29 November 2025

Our Ref: 27594-062-01
Council Ref: AP2024/013
QA: es

RESPONSE TO INFORMATION REQUEST (REFERRAL ENTITIES) – AP2024/013
Development Permit for Reconfiguring a Lot – Boundary Realignment (8 Lots into 4 Lots) combined with Material Change of Use for Warehouses in the Townsville State Development Area (SDA)

SHEET NAME:
PROPOSED FLOOR PLAN - LOT 01 & 02

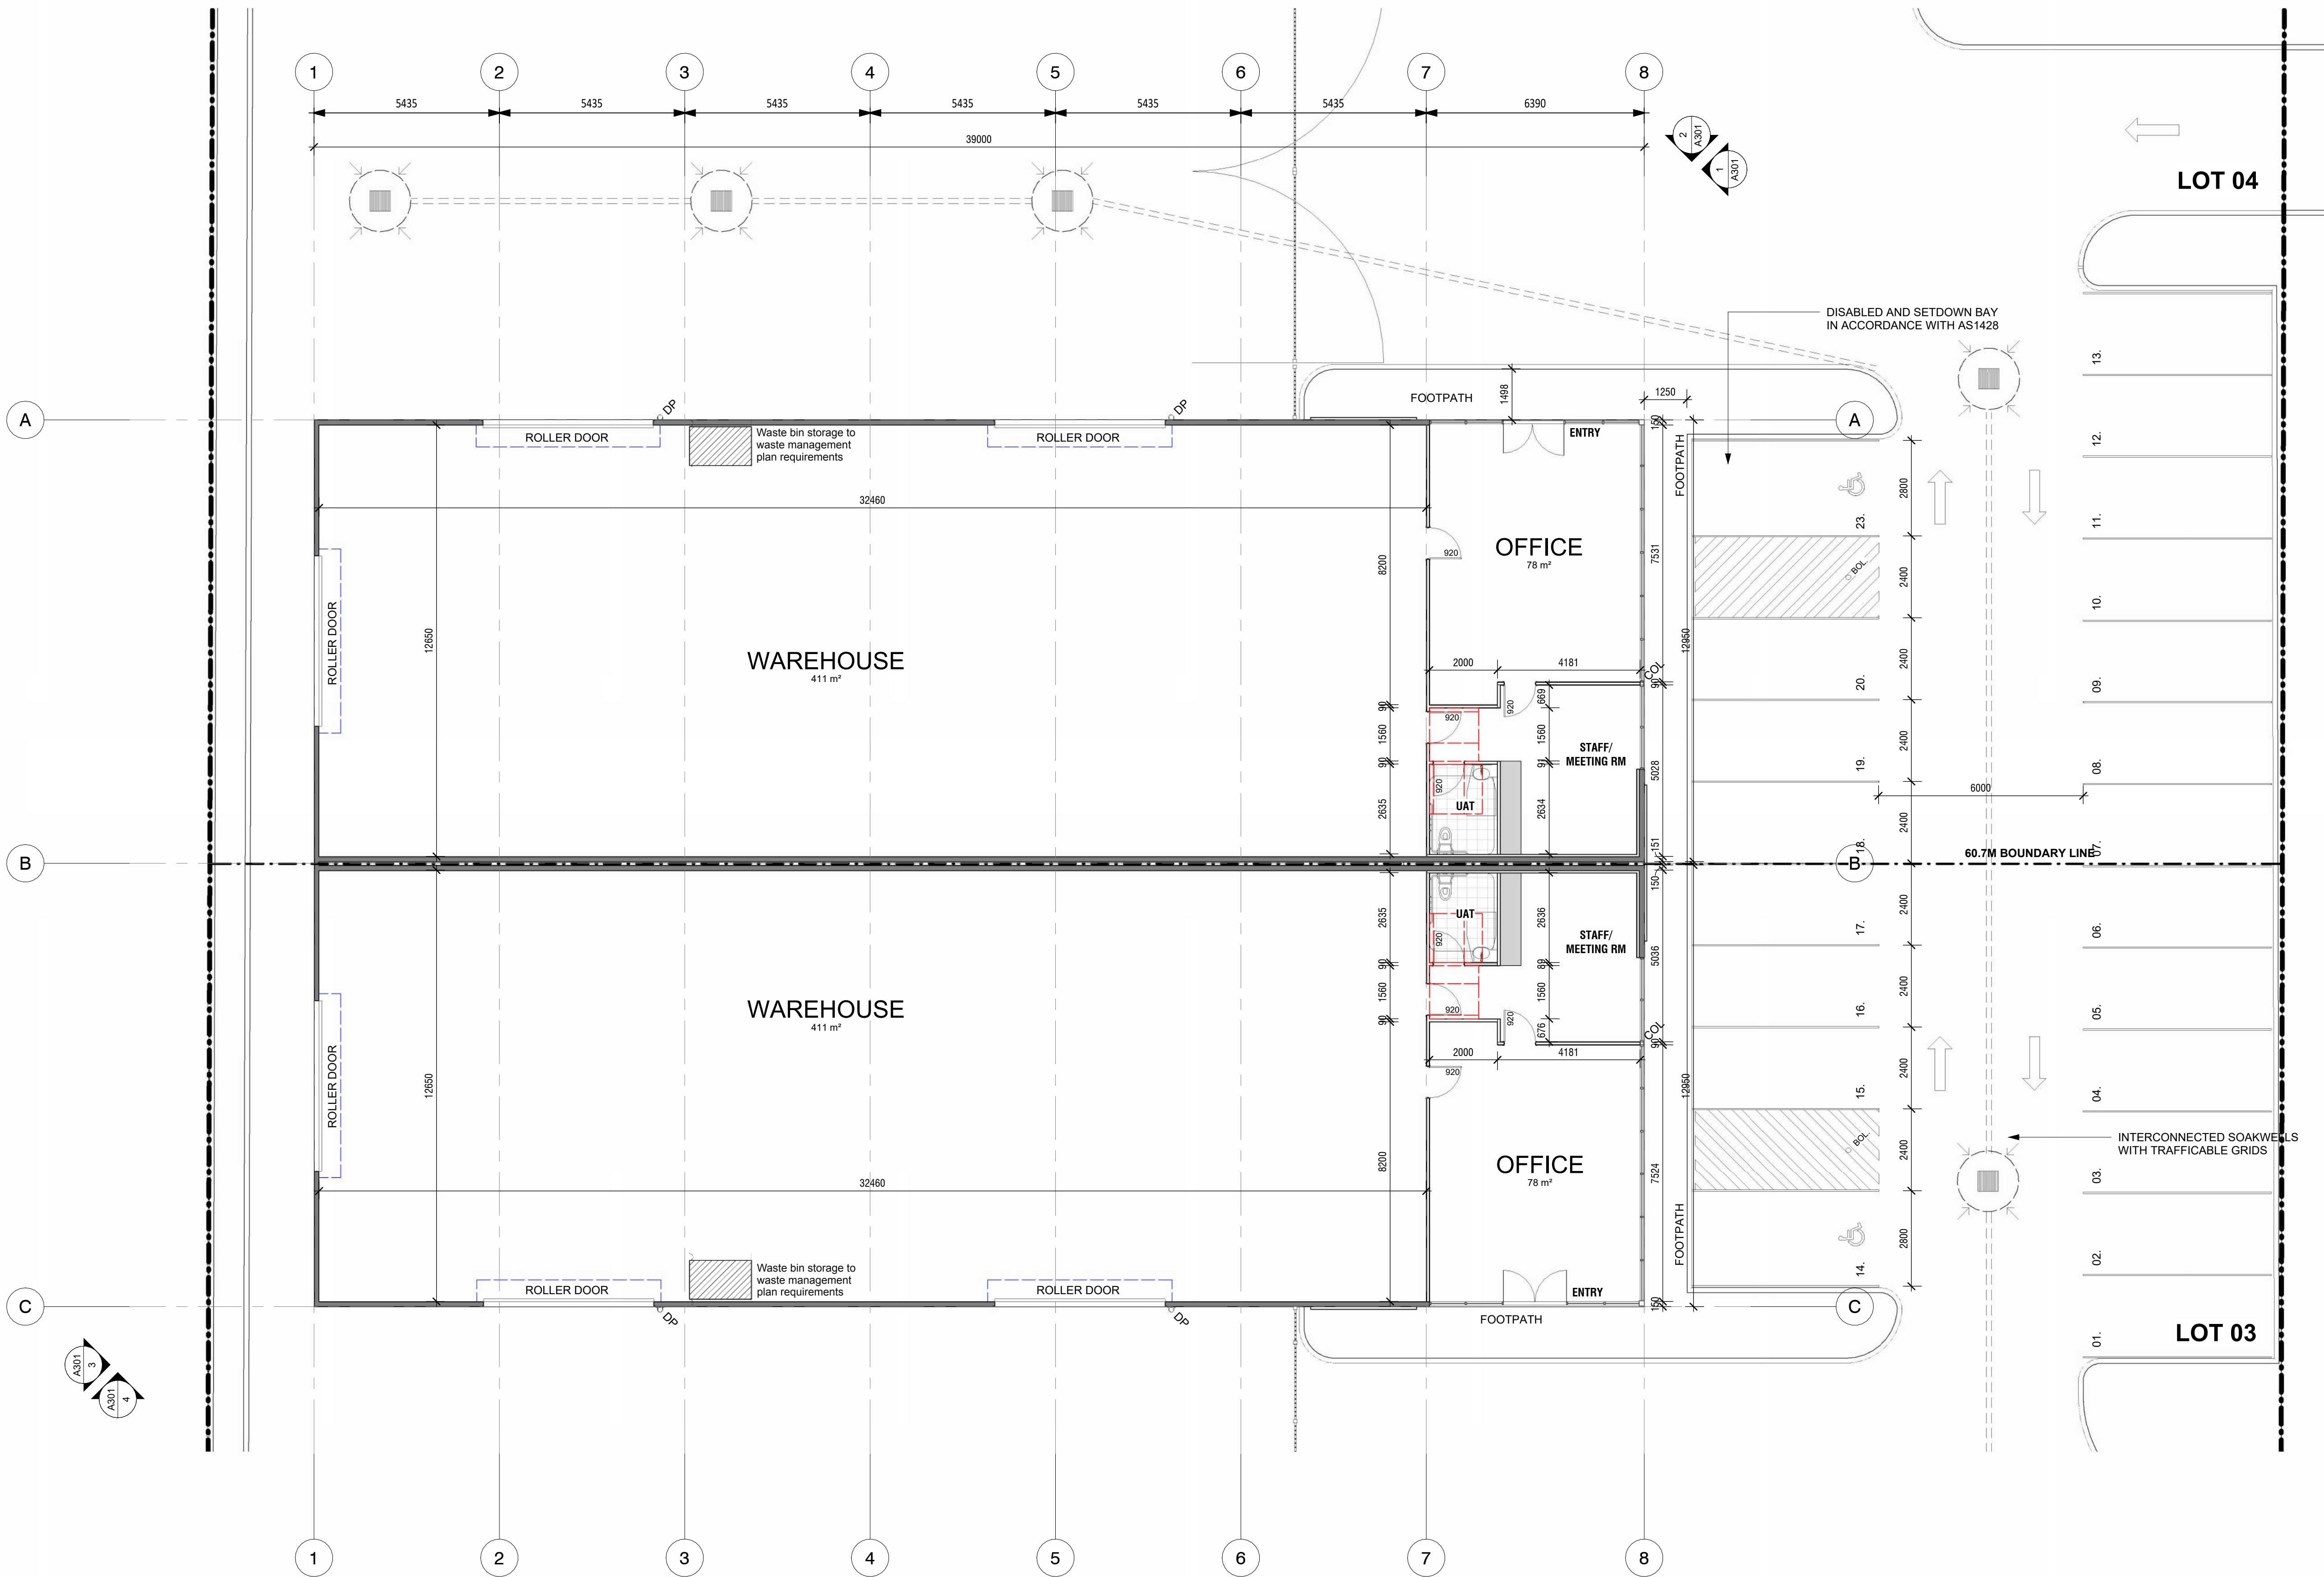
Furthermore, the development plans have been updated to identify the location of bin pads within the warehouses to demonstrate waste management provision for each lot. Access to these bin locations by a service vehicle has been previously demonstrated on the swept path analysis prepared by Brazier Motti.

NO.	DESCRIPTION	DATE
A	ISSUED FOR DA	28.10.2024
B	LOT SIZES UPDATED	26.02.2025
C	BUILDING SIZES AND PARKING LAYOUTS UPDATED	26.03.2025
D	3m SETBACK WITH TABLE DRAIN ADDED	26.05.2025
E	WASTE BIN STORAGE ADDED	29.08.2025

Figure 2-1 1% AEP flow hydrograph and required storage volume calculation

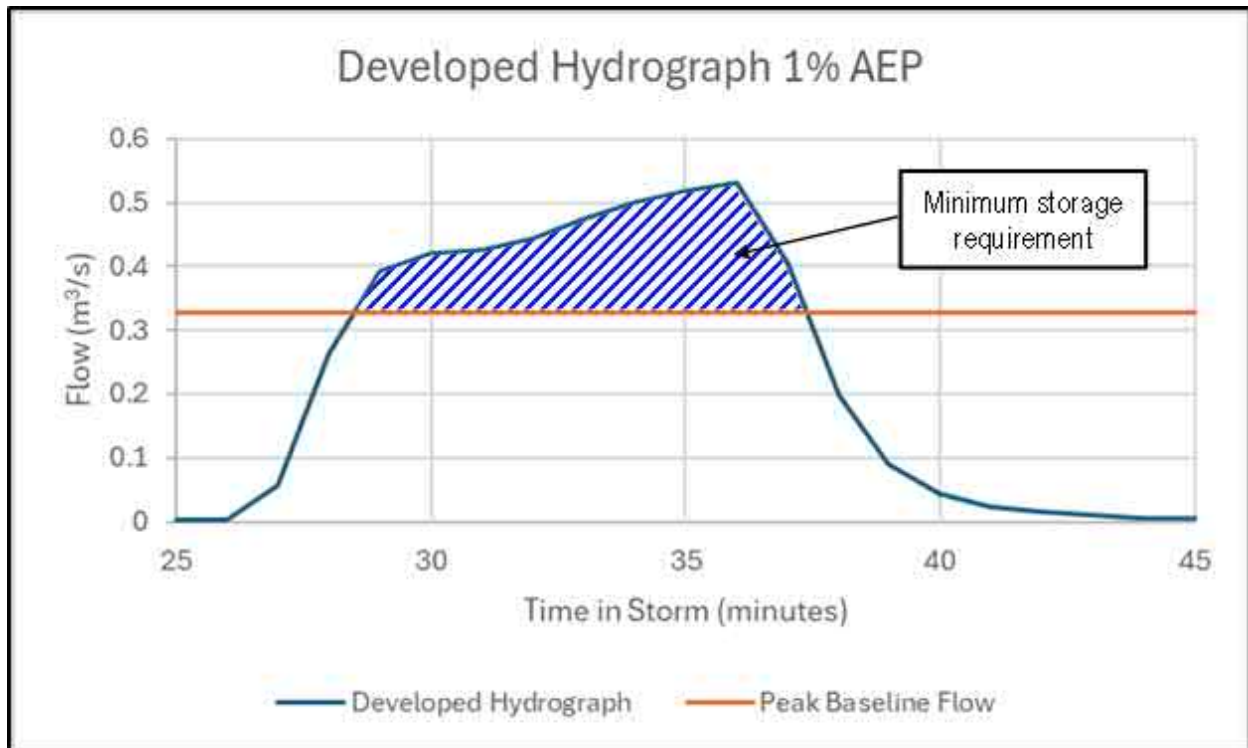
Simulations were run for existing (base), developed (unmitigated) and developed mitigated scenarios for both minor and major events. The peak flows are shown on **Table 2-1**. To determine the minimum storage requirements the flow hydrograph results have been extracted for the developed scenarios without mitigation. The area under the flow hydrograph but above the peak pre-development flow rate is the minimum volume required for mitigation. The results of the volume assessment are summarised in **Table 2-2**. **Figure 2-1** and **Figure 2-2** show the volume required for mitigation for the 1% AEP and 0.2EY events respectively.

Event	Storage Volume (m ³)
Minor (0.2 EY)	54
Major (1% AEP)	71

Figure 2-4 1% AEP WSL Afflux

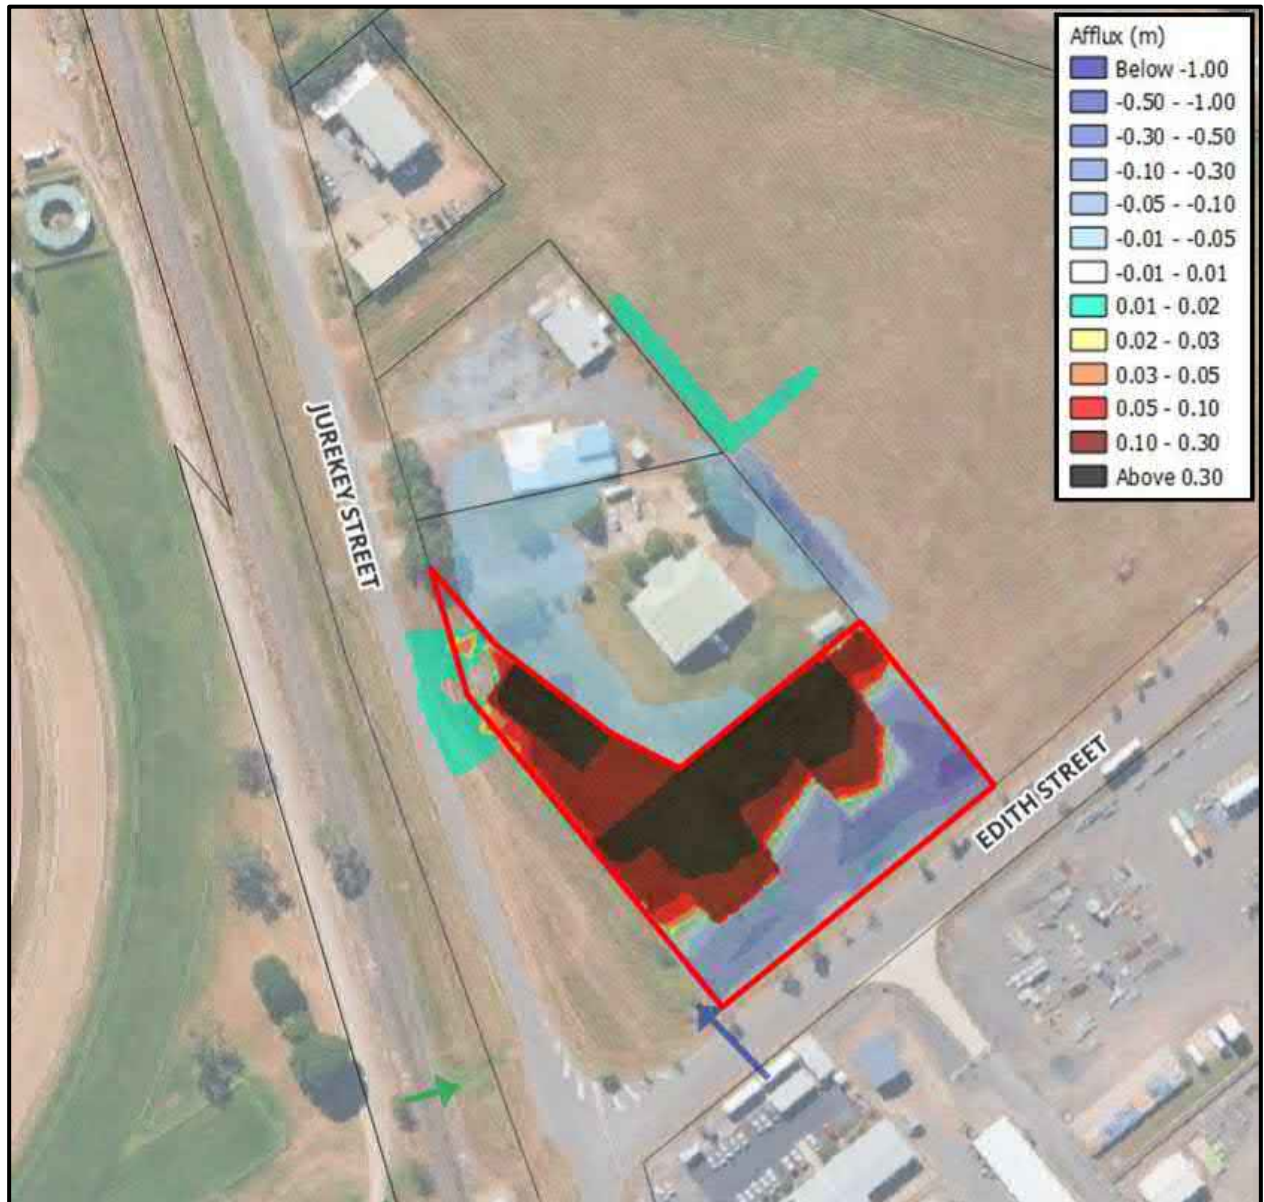
The resulting development impacts are shown in **Figure 2-4** and **Figure 2-5** for the 1% AEP and 20% AEP respectively. Afflux is defined as the relative change in a flooding characteristic, namely water surface level (WSL) or velocity, between the baseline and developed scenario. This is determined by subtracting the baseline peak results from the developed peak results, where a positive value represents an increase in the flood characteristic and a negative value is a decrease.

The above afflux mapping shows no impacts on the adjacent railway line to the west, no afflux over the adjacent roadways and no afflux on adjacent lots. Some highly localised, minor afflux is noted in the 1% AEP event through the Jurekey Street road reserve however, this is extremely minor and does not impact on the roadway trafficability or change the hazard level. Some afflux is generated through the easements on the adjacent lots owned by Toprise to the north-east in both events.

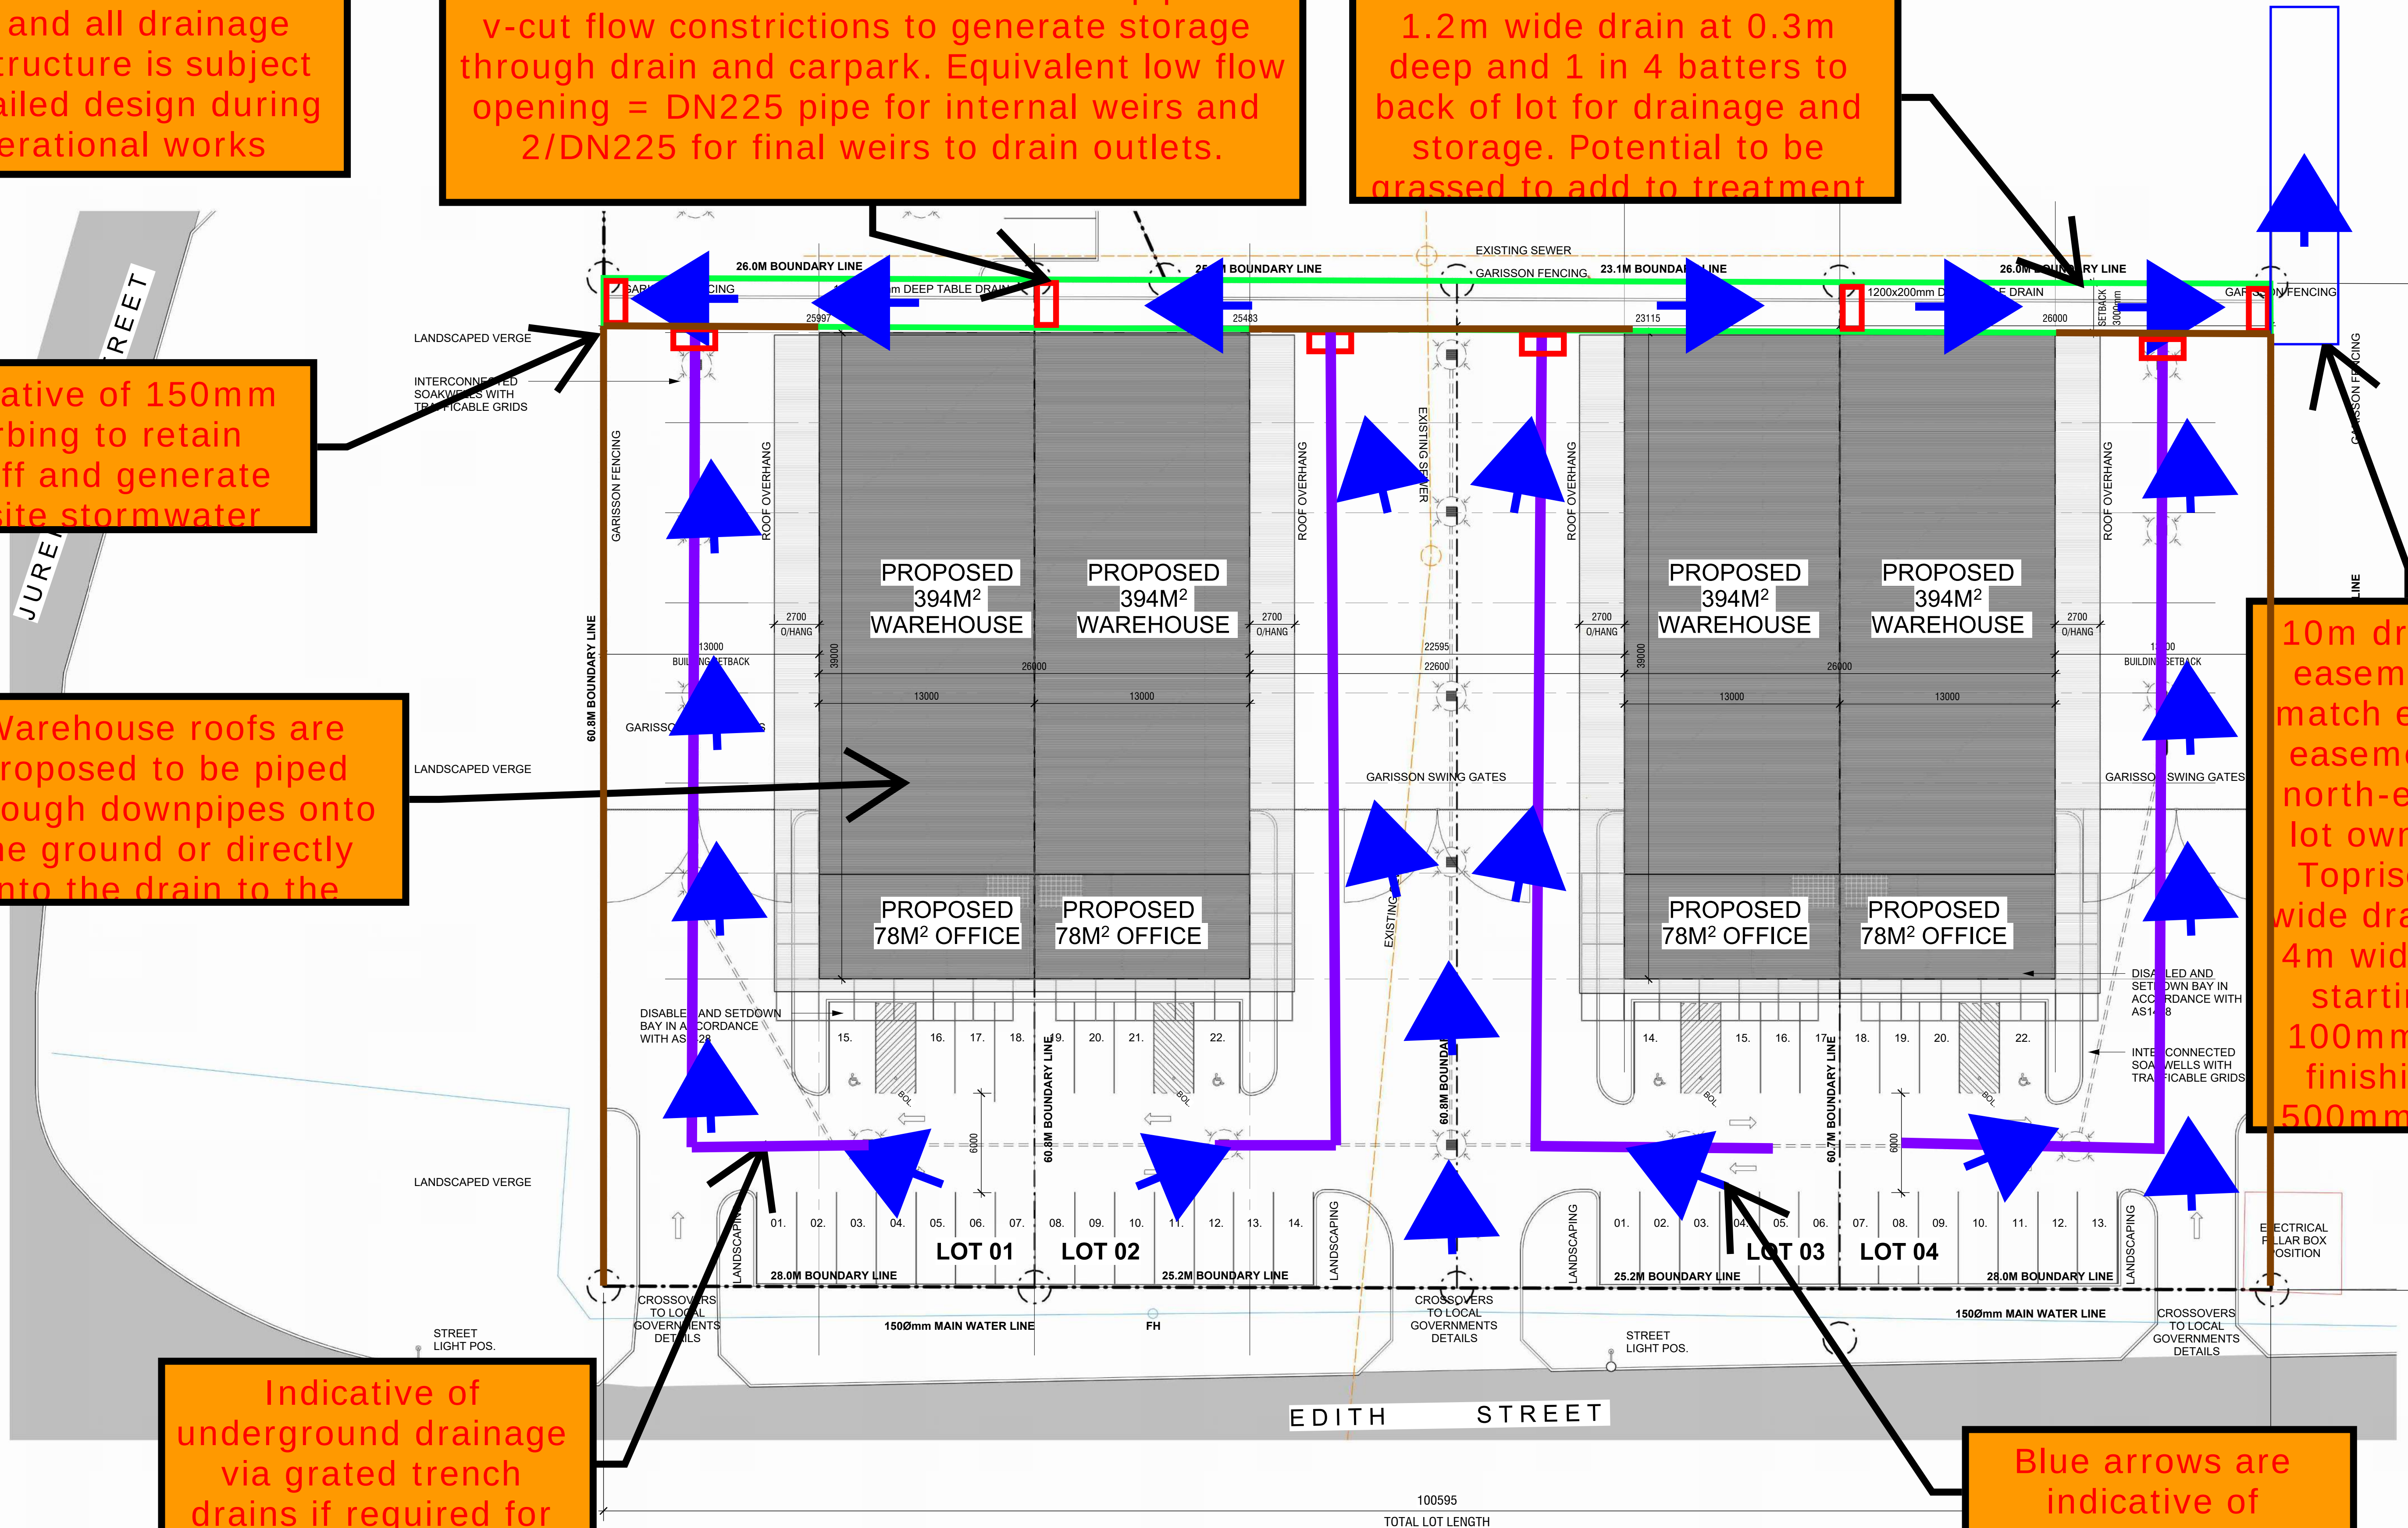
The redline concept markup provided within the Site Based Stormwater Management Plan report shows the mitigation measures which have been modelled to generated the above ponding indicated on site. The detailed design is to be implemented strictly in accordance with the redline concept design.

Indicative of weir walls with low flow pipes or v-cut flow constrictions to generate storage through drain and carpark. Equivalent low flow opening = DN225 pipe for internal weirs and 2/DN225 for final weirs to drain outlets.

1.2m wide drain at 0.3m deep and 1 in 4 batters to back of lot for drainage and storage. Potential to be grassed to add to treatment

Indicative of 150mm kerbing to retain runoff and generate onsite stormwater

Warehouse roofs are proposed to be piped through downpipes onto the ground or directly into the drain to the
